STAFF RECOMMENDATION
2708 Belmont Boulevard
August 21, 2013

Application: New construction-addition
District: Belmont-Hillsboro Neighborhood Conservation Zoning Overlay
Council District: 18
Map and Parcel Number: 11704019900
Applicant: Van Pond, architect
Project Lead: Sean Alexander, sean.alexander@nashville.gov

Proposed Site Plan

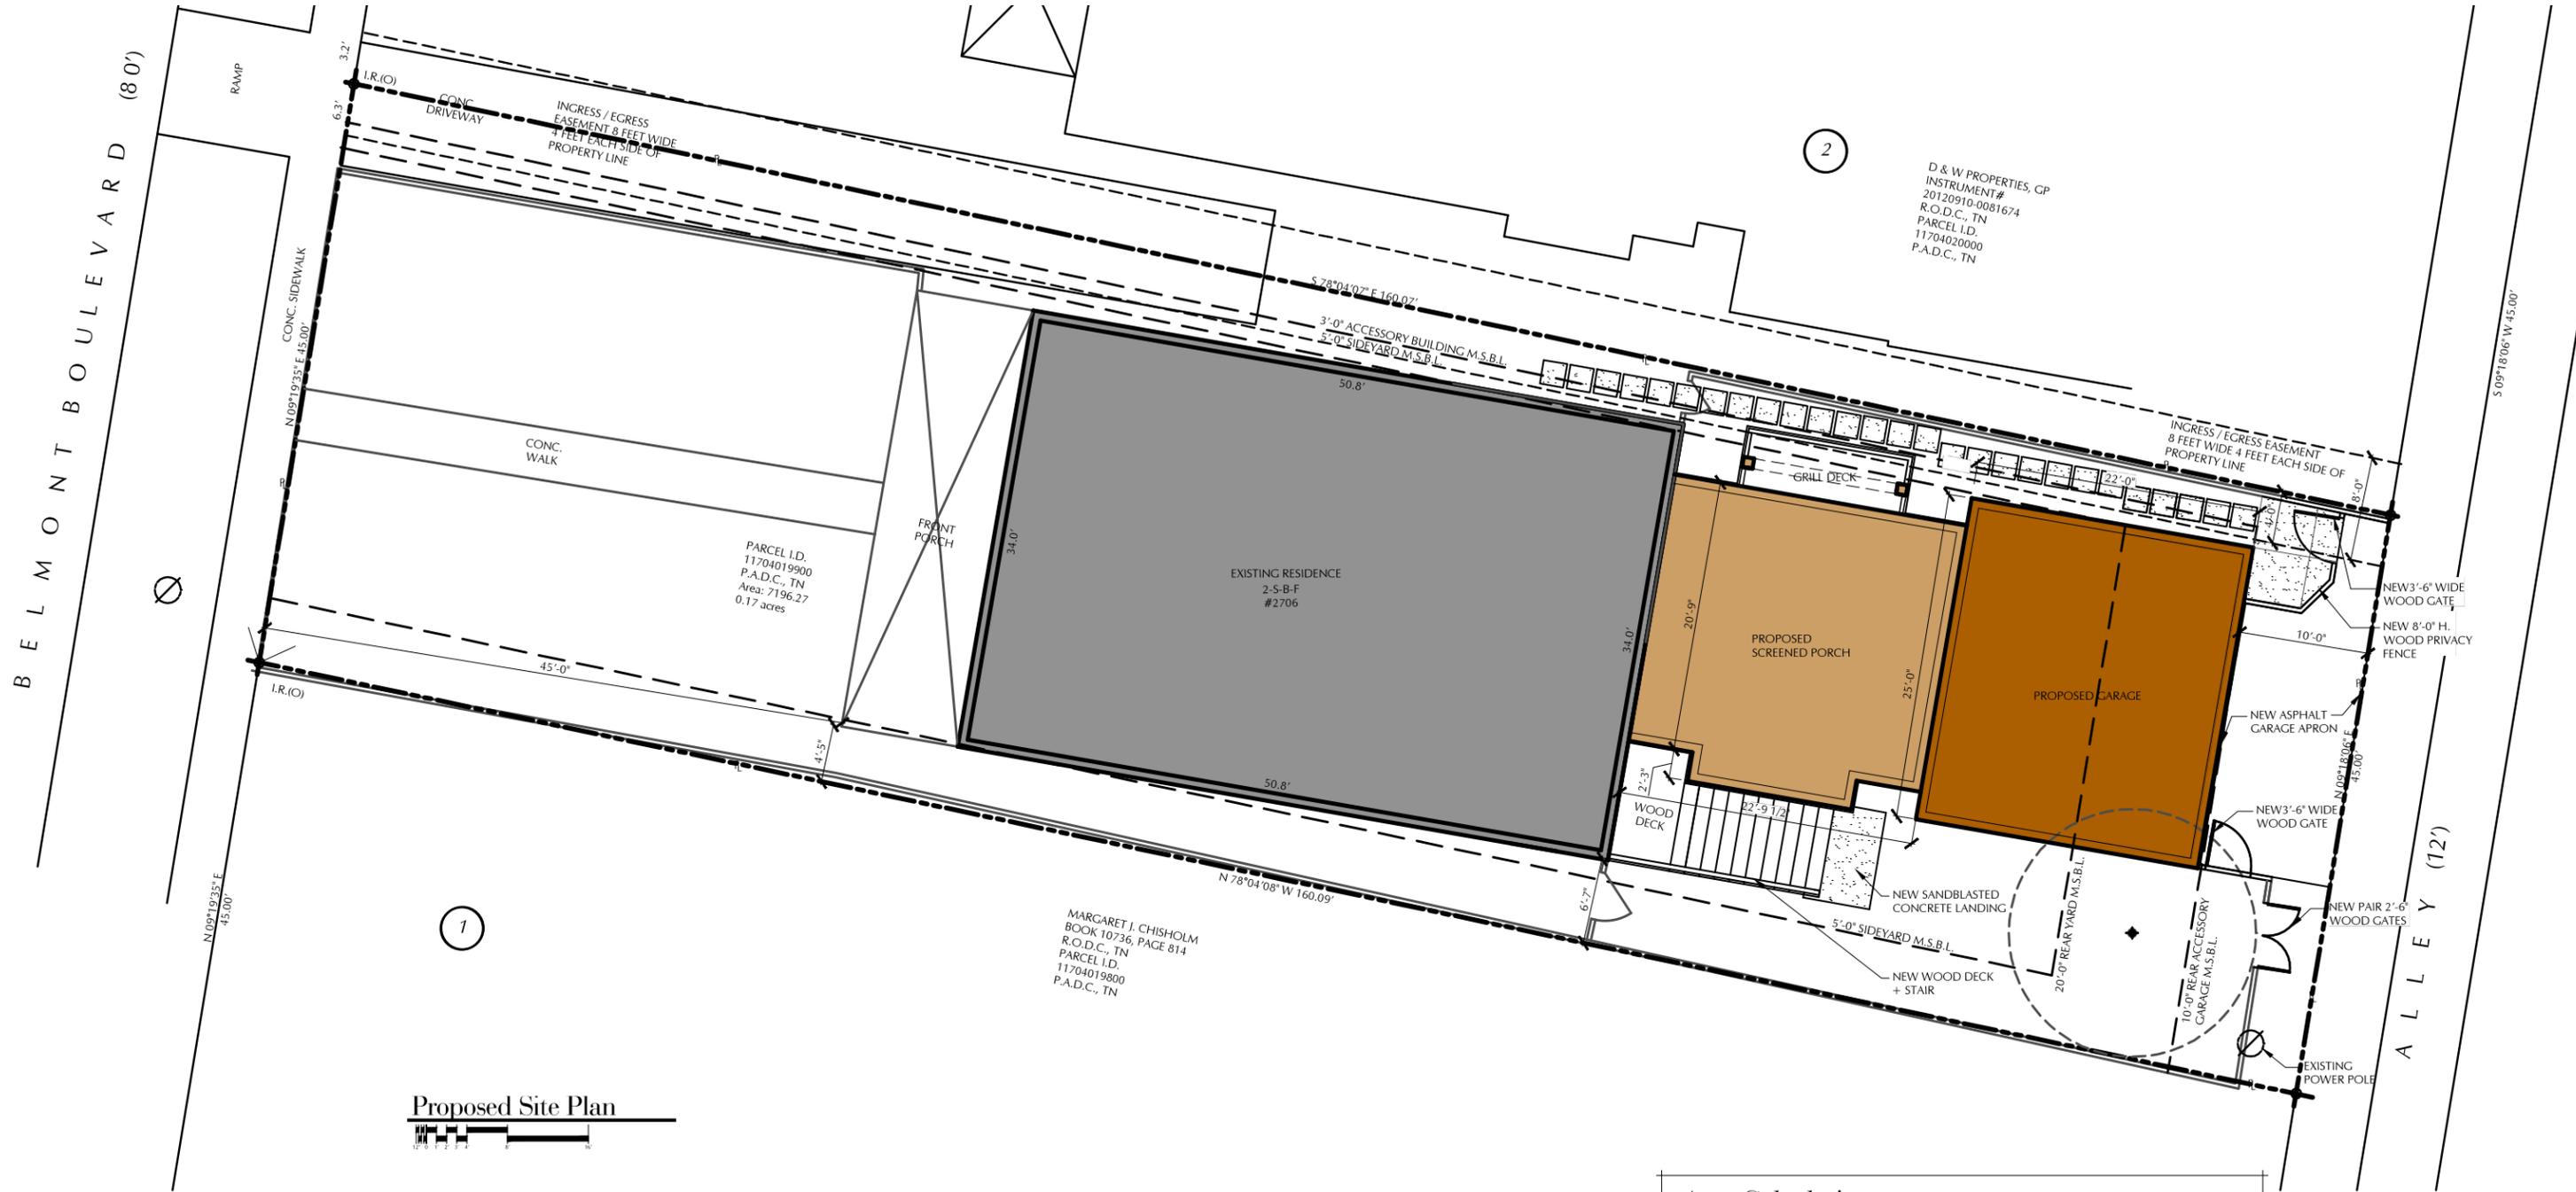
The addition will be subordinate in height to the historic house and would meet guidelines II.B.1.a, but increases the total depth of the building to one hundred, four feet (104') and places the rear wall of the building only ten feet (10') from the rear property line. As the required minimum setback for a primary building would be twenty feet (20'), the Commission would need to reduce the setback in approving the addition.

Staff finds that the lot is not unusual in terms of its shape, size or building location, and that there is not sufficient need for a setback reduction. For this reason, staff finds that the scale of the addition would not meet guidelines II.B.1.b and II.B.1.c.

The addition could be shortened to meet the existing twenty-foot (20') requirement.
